111685 - 00

Change Notification #: 111685 - 00
Change Title: Intel® Server Chassis P4304XXSFDR
PCN 111685-00, Product Design
Update Power Supply
Date of Publication: August 14, 2012

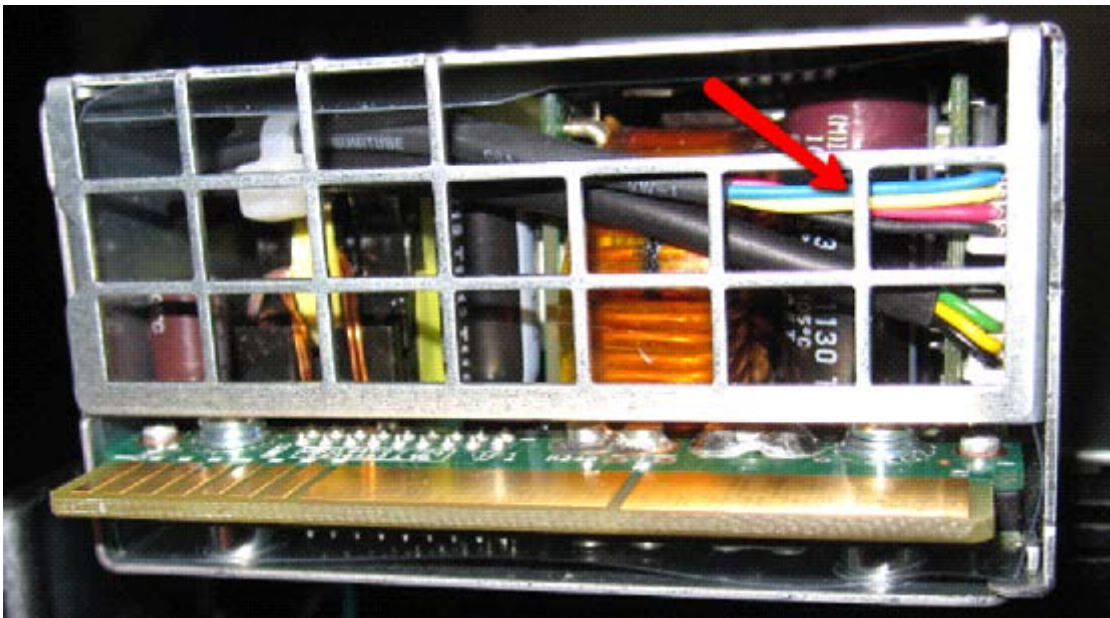
1. The firmware of the 460W Common Redundant Power Supply is updated to improve the system power stability during power capping for Node Manager Implementation.
2. The shrink tube around the Power Supply wires inside the forward ends of the Power Supplies is lengthened. This prevents the wires from rubbing against the grill and cutting into the insulation during vibration. See below picture:
